Docket Item #14
BAR CASE# 2004-0233

BAR Meeting
November 3, 2004

ISSUE: Addition
APPLICANT: Richard Clausen
LOCATION: 6 Potomac Court
ZONE: RM/Residential

Figure 1 -Rear Elevation

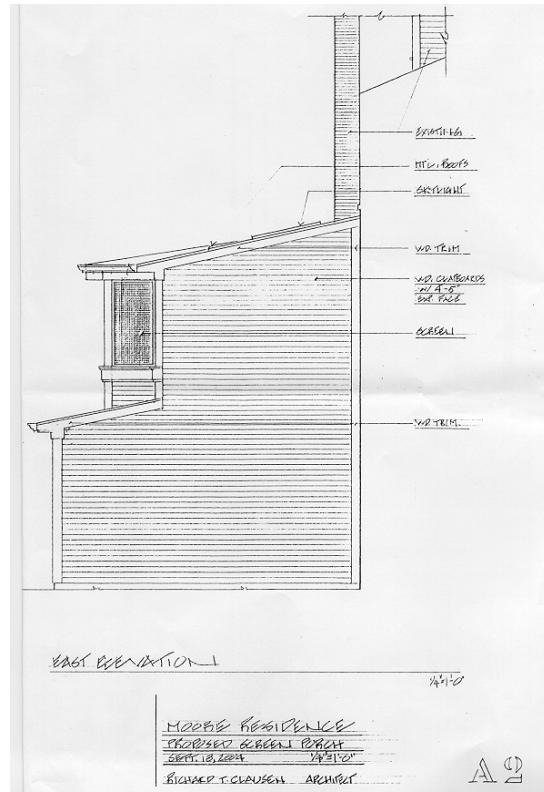
The applicant is requesting approval of a Certificate of Appropriateness for the construction of a screened porch at the first floor level of the house at the rear. The three story brick townhouse has a raised basement with a sunroom addition at the rear of the basement level. The new screened porch will be located on top of the sunroom addition, replacing the existing open deck. The porch will cover the full width of the house but will not extend out the full depth of the sunroom addition below. It will be 20' wide by 11'6" deep. A 9'6" wide central bay will project out another 3'. The flat roof of the sunroom addition will be changed to sloping roof clad with standing seam metal. The base of the new porch addition will be clad in wood clapboard siding with a 4" exposure. The central projecting section will have three screen sections while the recessed flanking sections will have two each. The trim will be wood. The porch will have a shed roof clad in standing seam metal. There will be three flat skylights in the upper portion of the roof and aluminum gutters at the eaves. On the west side, the addition will run to and capulate the brick wall of 5 Potomac Court, which extends well beyond 6 Potomac Court. On the east side, the wall of the addition will be located on the property line and will be exposed, as 4 Potomac Court does not extend as far back. The east wall will be clad in wood clapboard siding with a 4" exposure.

- F-1 The existing window in the party wall of #5 Potomac Court creates a fire separation issue for the proposed project. The applicant shall schedule a meeting with Code Enforcement in order to resolve fire separation issues created by this pre-existing condition prior to moving ahead with this project.

- C-1 All exterior walls within 5 feet from an interior property line shall have a fire resistance rating of 1 hour, from both sides, with no openings permitted within the wall. As alternative, a 2 hour fire wall may be provided.
